Service Bulletin No. 1067A

COACH MODEL	: T2100 Series ; C2000 Series
BULLETIN TYPE	: Service information
MANUAL & SECTION	: Maintenance Manual : Chapter 10 - HVAC System
DATE	: February 28th, 2001
SUBJECT	: Refrigerant charge - change of procedure
TERMS & CONDITIONS	: No claims will be accepted with reference to this Bulletin.

THIS BULLETIN SUPPLEMENTS BULLETIN 1067 FOR PDI PURPOSES ONLY

Figure 1: Jumper wire installation on the HVAC switchboard for PDI purposes (T2145 - Sytronic)

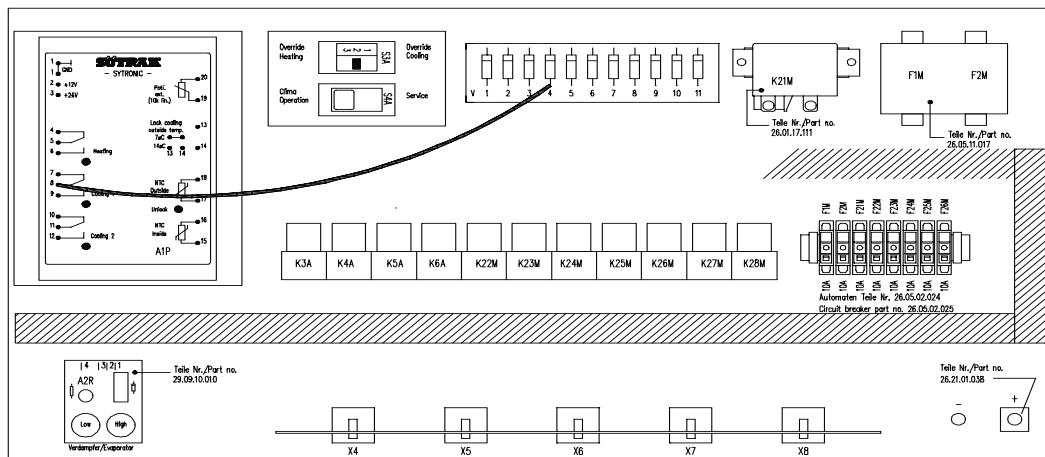
An alternative method to keep the interior temperature steady, is to install a jumper wire in the HVAC junction box as indicated in the chart below :

Coach type	Model	Controller type	Controller terminal #	Diode #	Refer to
Touring	T2145	Sytronic	8	4	Figure 1
Commuter	C2045	Sytronic 2	11	4	Figure 2
